# Office Action Summary

10/588,463

VOGELIN ET AL.

### **DETAILED ACTION**

**Fig B**

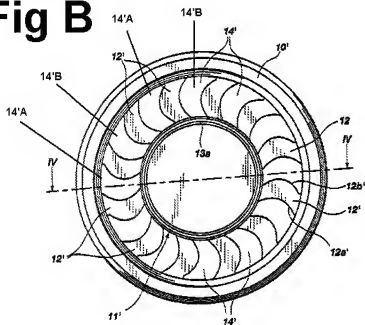
Guala, however, teaches a diaphragm valve 9' (Fig 2) having elongate openings 14'A (best seen in Fig B below) which are uniformly distributed along a circle in the periphery of the diaphragm (as seen in Fig 2) wherein the elongate openings are separated from one another by webs 12' (Fig 2) and compact openings 14'B (best seen in Fig B below) which are present adjacent to the webs (as seen in Fig B below) for the purpose of allowing communication between two passageways (Col 5, Lines 41-43). Therefore, it would have been obvious to one of ordinary skill in the art at the time the invention was made to modify Samson to include a diaphragm valve having elongate openings and compact openings separated by webs, as taught by Guala, for the purpose of allowing communication between two passageways (Col 5, Lines 41-43).

Guala, however, teaches a diaphragm valve 9' (Fig 2) having elongate openings 14'A (best seen in Fig B above) which are uniformly distributed along a circle in the periphery of the diaphragm (as seen in Fig 2) wherein the elongate openings are separated from one another by webs 12' (Fig 2) for the purpose of allowing communication between two passageways (Col 5, Lines 41-43). Therefore, it would have been obvious to one of ordinary skill in the art at the time the invention was made to modify Samson to include a diaphragm valve having elongate openings separated by

Guala, however, teaches a diaphragm valve 9' (Fig 2) having elongate openings 14'A (best seen in Fig B above) which are uniformly distributed along a circle in the periphery of the diaphragm (as seen in Fig 2) wherein the elongate openings are separated from one another by webs 12' (Fig 2) for the purpose of allowing communication between two passageways (Col 5, Lines 41-43). Therefore, it would have been obvious to one of ordinary skill in the art at the time the invention was made to modify Samson to include a diaphragm valve having elongate openings separated by webs, as taught by Guala, for the purpose of allowing communication between two passageways (Col 5, Lines 41-43).

**Fig D**

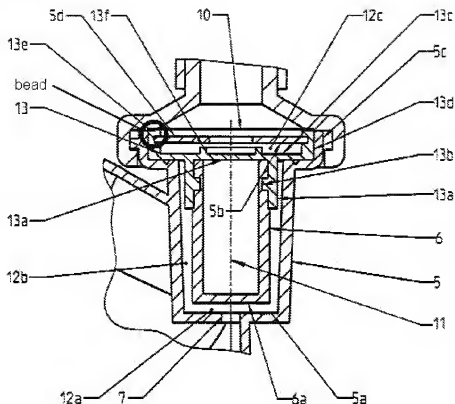
26. Re claim 36, Samson/Guala disclose all the claimed features except that the cylindrical jacket is provided with a bead extending at least partially about the circumference. Nuesch, however, teaches a cylindrical jacket 13d (Fig 3) having a bead (formed above groove 13e as seen in Fig D below) extending about the circumference for the purpose of holding parts of the valve in a specific configuration (Col 4, Lines 26-27). Therefore, it would have been obvious to one of ordinary skill in the art at the time the invention was made to modify Samson/Guala to include a bead, as taught by Nuesch, for the purpose of holding parts of the valve in a specific configuration (Col 4,
